Planning Application PL/2026/01223
Manorfield Farm, Manningford Abbots, SN9 6HY
Comments on proposed variation of conditions

From Mr A & Mrs C Mortimer

12 March 2026

Comparison of building height proposed and previously approved PL/2025/04825

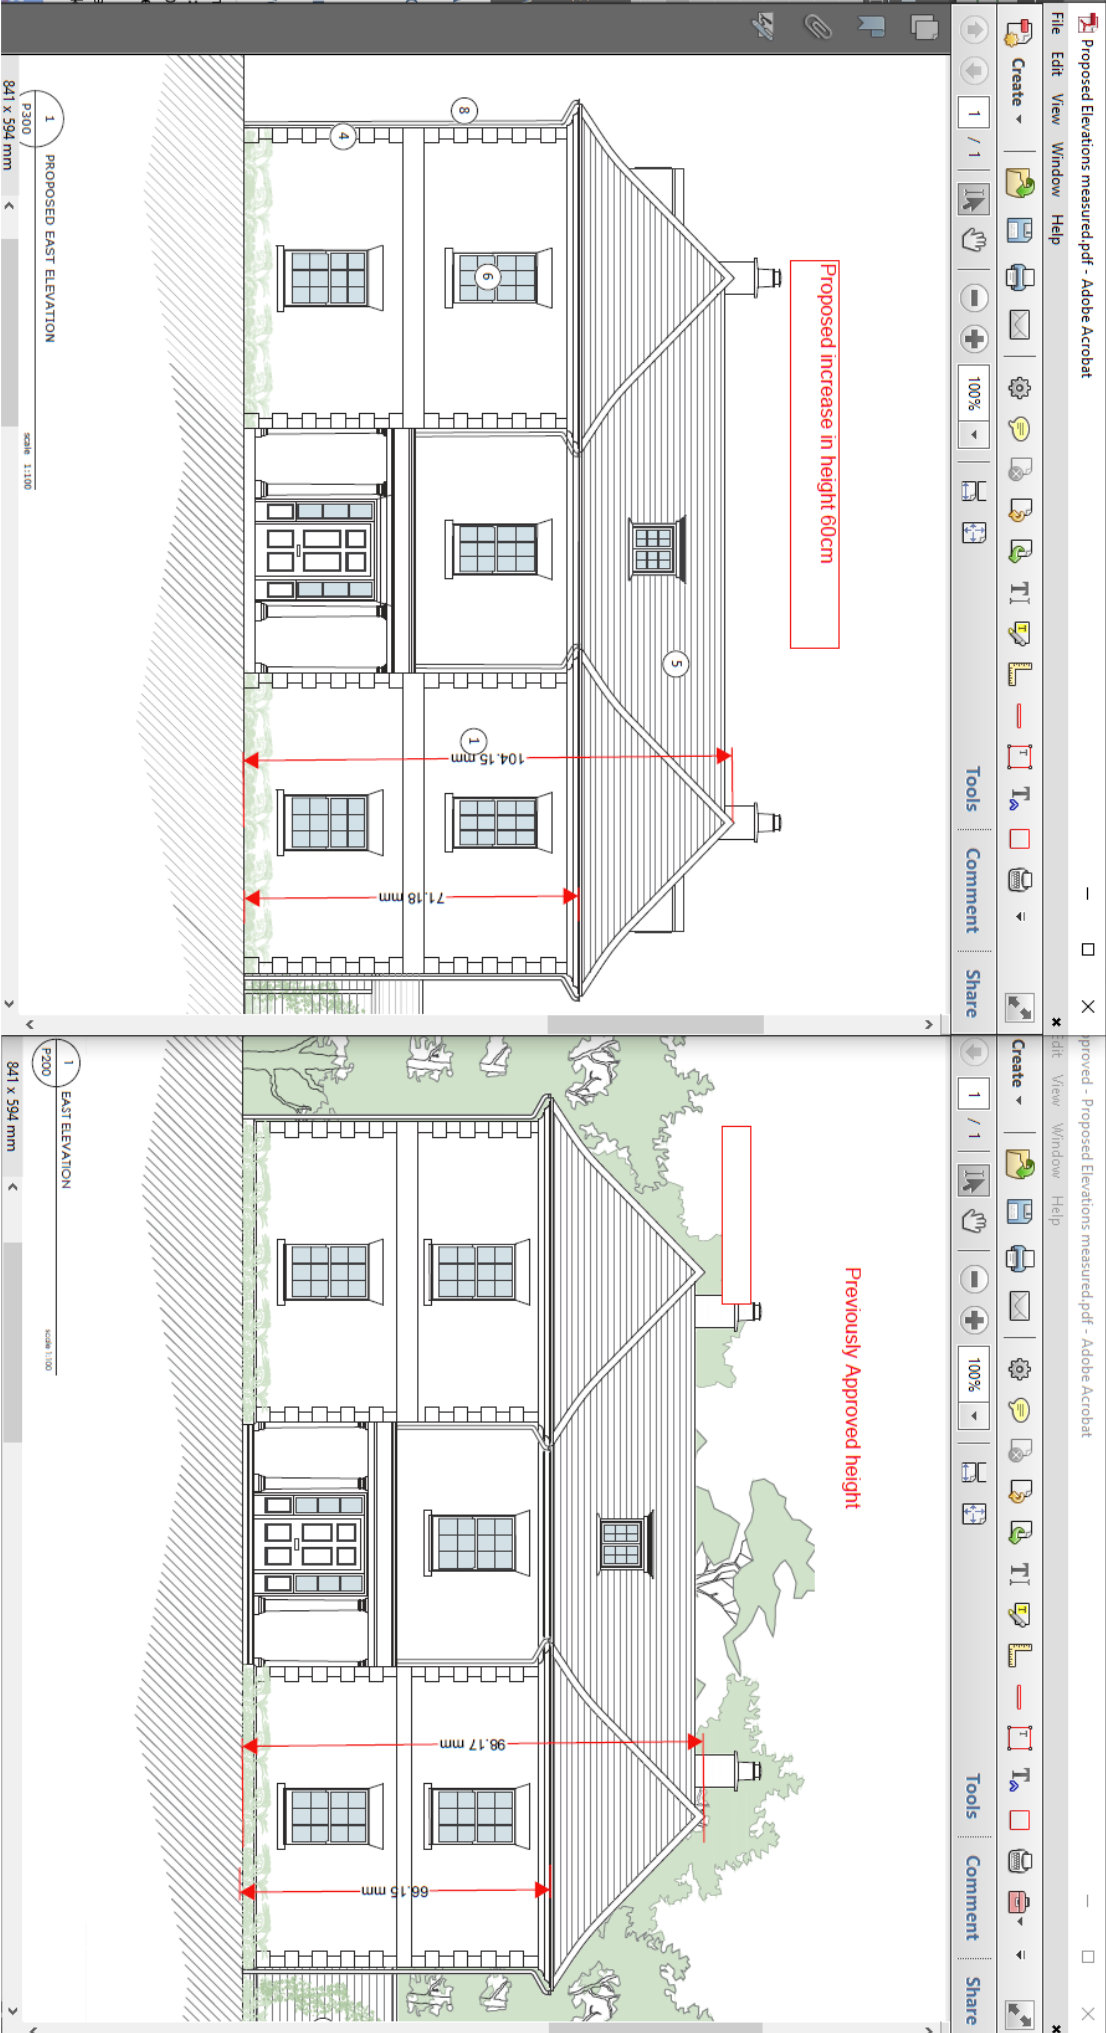
We cannot find any explicit definition of the increase in height proposed, but the plans show the proposed increase for the dwelling to be 60cm (almost 9% taller) and for the garage 30cm, using the “measure” tool as described in the published details on the Council website.

We doubt if this increase in height should be described as “minor”. This suggests that close examination of the submitted plans is required to understand the details of the proposals.

There is an illustration of this comparison on the next page, using sections from the published elevation plans at the same scale.

The house has already become 3m deeper towards the west than originally approved, and with the additional height will be even more imposing and noticeable. It will be visible from neighbouring properties and from the well-used Manningford Footpath 16 to the south.
